**CITY PLAN COMMISSION****THURSDAY, SEPTEMBER 07, 2023****FILE NUMBER:** S223-228**SENIOR PLANNER:** Hema Sharma**LOCATION:** bounded by Martin Luther King Jr. Boulevard, Harwood Street, Peabody Avenue and Central Expressway**DATE FILED:** August 10, 2023**ZONING:** PD 595 (Subdistrict CC & P(A))**PD LINK:** <https://dallascityhall.com/departments/city-attorney/Articles/PDF/Article%20595.pdf>**CITY COUNCIL DISTRICT:** 7**SIZE OF REQUEST:** 1.8846-acres**APPLICANT/OWNER:** Forest Forward

**REQUEST:** An application to replat a 1.8846-acre tract of land containing all of Lots 1 through 5, 8 through 11, part of Lots 6 and 12 in City Block 10/1152 and a portion of an abandoned alley to create one lot on property bounded by Martin Luther King Jr. Boulevard, Harwood Street, Peabody Avenue and Central Expressway.

City Plan Commission Date: 09/07/2023 20(g) S223-228

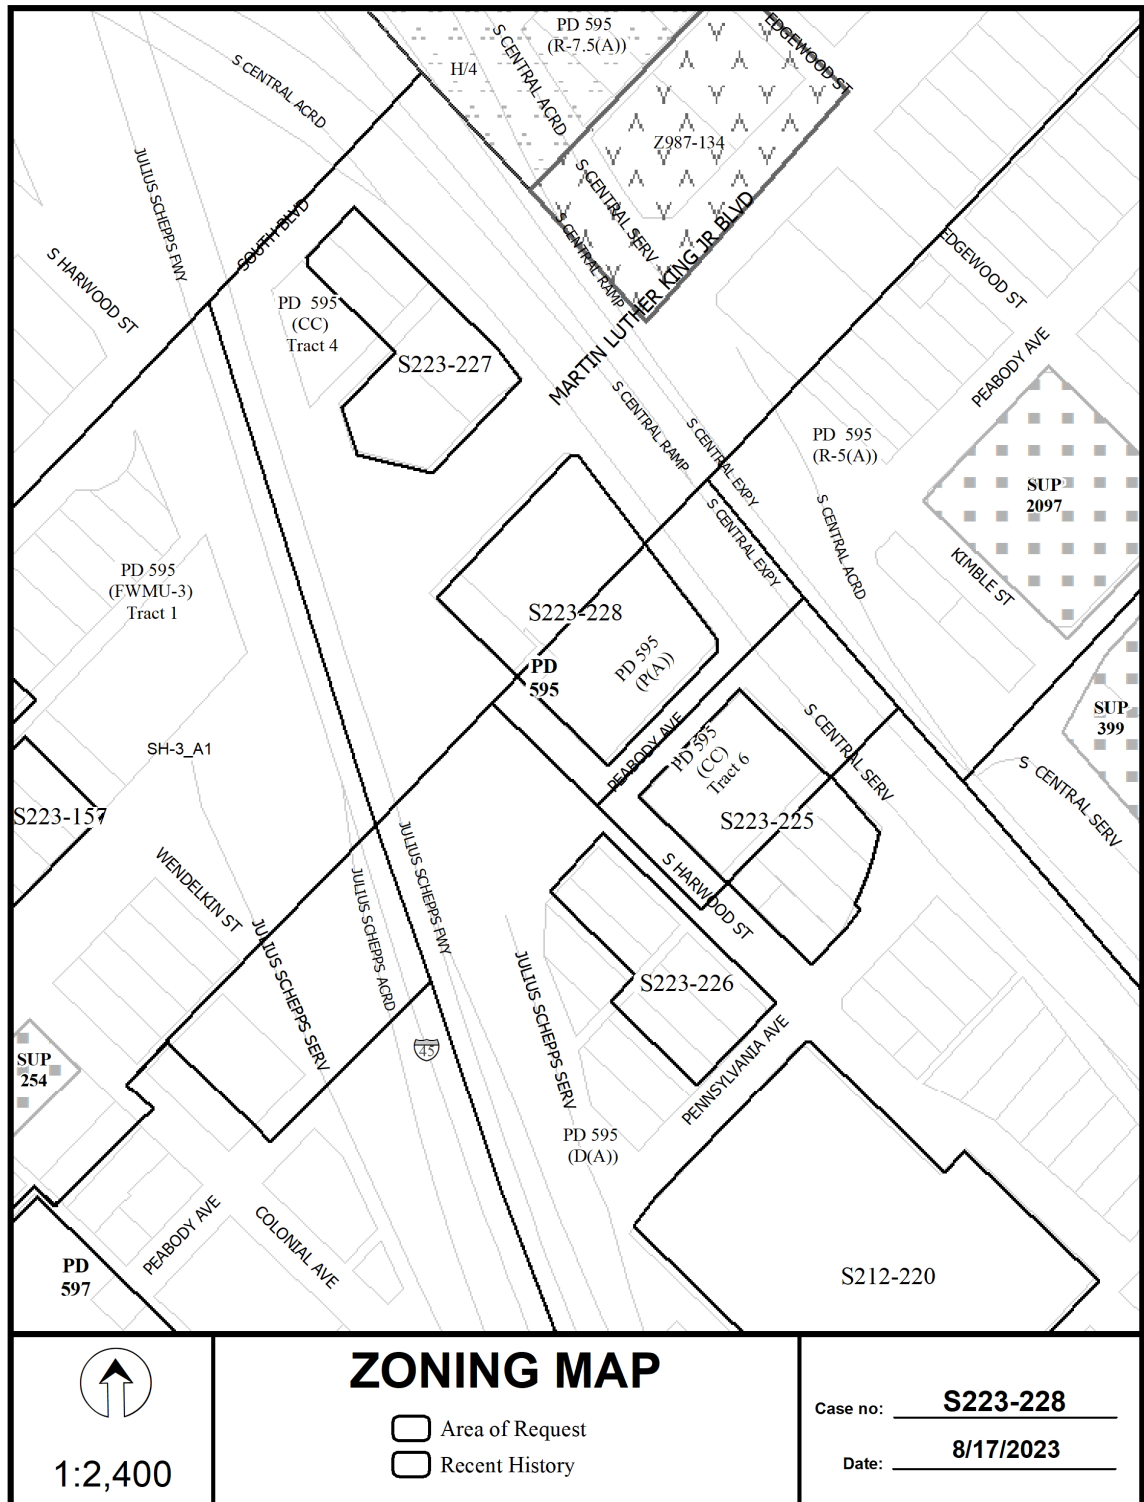
15. On the final plat, dedicate a minimum 5-foot by 5-foot corner clip (via fee simple or street easement) at the intersection of Peabody Avenue & Harwood Street. Section 51A 8.602(d)(1)

16. On the final plat, dedicate a minimum 5-foot by 5-foot corner clip (via fee simple or street easement) at the intersection of Central Expressway (A.K.A. S.M. Wright Frwy) & Peabody Avenue. Section 51A 8.602(d)(1)

20. On the final plat, dedicate a minimum 20-foot by 20-foot corner clip (via fee simple or street easement) at the intersection of Harwood Street & Martin Luther Jr. Boulevard

21. On the final plat, dedicate a minimum 20-foot by 20-foot corner clip (via fee simple or street easement) at the intersection of Martin Luther Jr. Boulevard & Central Expressway (A.K.A. S.M. Wright Frwy).

28. Existing and any proposed Water and Wastewater Easements must be shown and/or increased to conform to current design standards. **Notice:** Minimum DWU easement size 20' for one utility and 25' for both water and sewer. Larger diameter or deeper mains may require additional width.

29. On the final plat, please show the alley abandonment on the plat as follows: Abandonment authorized by Ordinance No. \_\_\_\_\_, recorded as Inst. Nos. (Cert. ORD No. \_\_\_\_\_, QCD No. \_\_\_\_\_). Utility Easements retained. Please provide a copy of Ordinance No. 4320
30. On the final plat, change "S Harwood Street" to "Harwood Street"/ Change "175 SM Wright Freeway" to "Central Expressway (A.K.A.S.M. Wright Freeway)".
31. On the final plat, identify the property as Lot 1A in City Block 10/1152. Ordinance 1A, Page 131 pages 131-148, Section 2 (passed August 13, 1872).
